World Forum for Harmonization of Vehicle Regulations

183rd session

Proposal for Supplement 24 to the original series of amendments to UN Regulation No. 54 (Tyres for commercial vehicles and their trailers)

Submitted by the Working Party on Noise and Tyres*

Figure, amend to read:

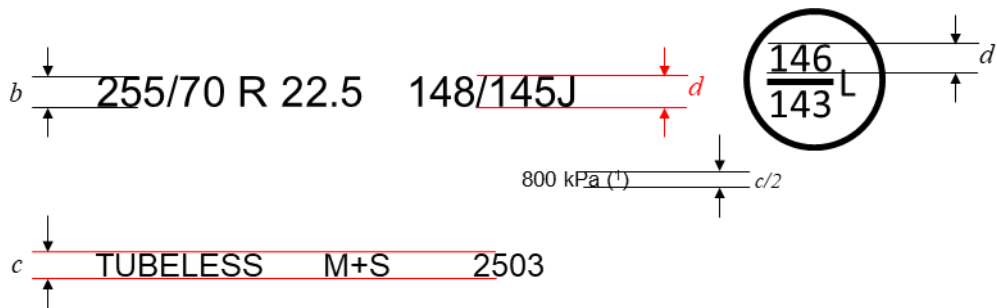
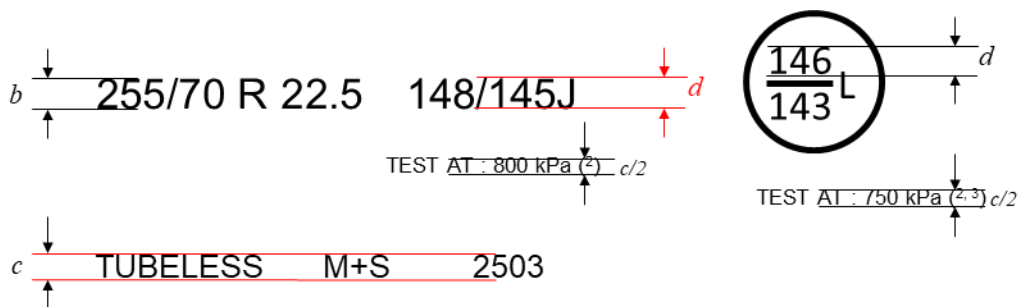
"Example 1:

(1) PSI marking instead of kPa is allowed for tyres first type approved before 1 January 2018. The kPa marking may be preceded by "TEST AT : " or, alternatively, by "TEST INFL : " or the symbol "@".

Example 2:

- (²) "TEST AT :" may be replaced by "TEST INFL :" or the symbol "@" or be omitted.
- (³) The indication of a second inflation pressure for the additional service description is optional. If there is no indication, the same test inflation applies to both load/speed combinations.

Dimensional requirements for further markings (⁴):

- (⁴) For "ML" and "MPT" being part of the tyre size designation marking the minimum dimension *b* applies."
